# Product Change Notification

**Change Notification #:** 816910-00

**Change Title:** Select Intel® Ethernet Network Adapters  
PCN 816910-00, Product Design,  
Bracket Shipping Configuration Change

**Date of Publication:** February 29, 2024

**Current X550T2G1P5 Configuration**

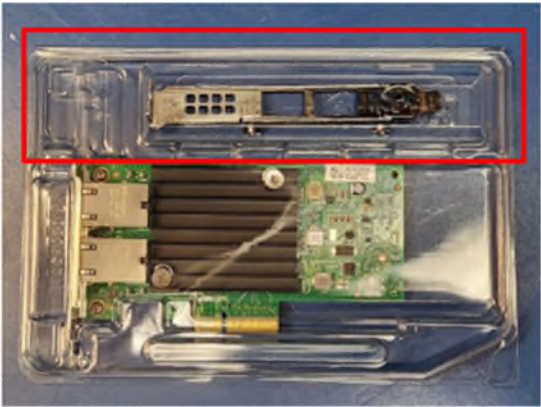
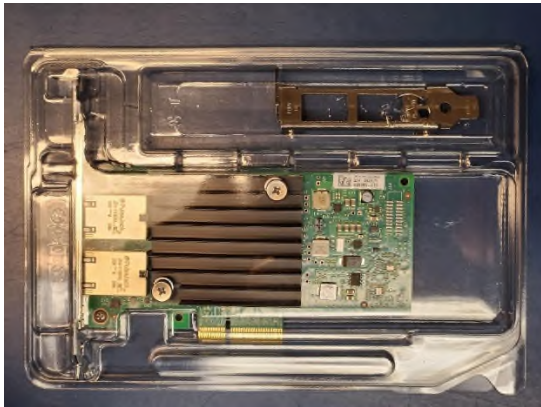
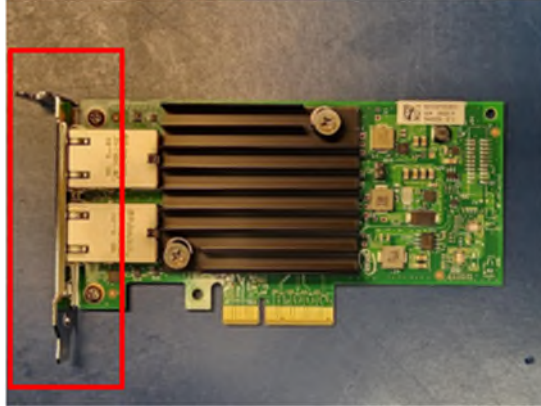
- The bracket shipping configuration will change. These products will now ship with the Low-profile bracket installed on the adapter and the Full-height bracket loose in the clamshell pocket.
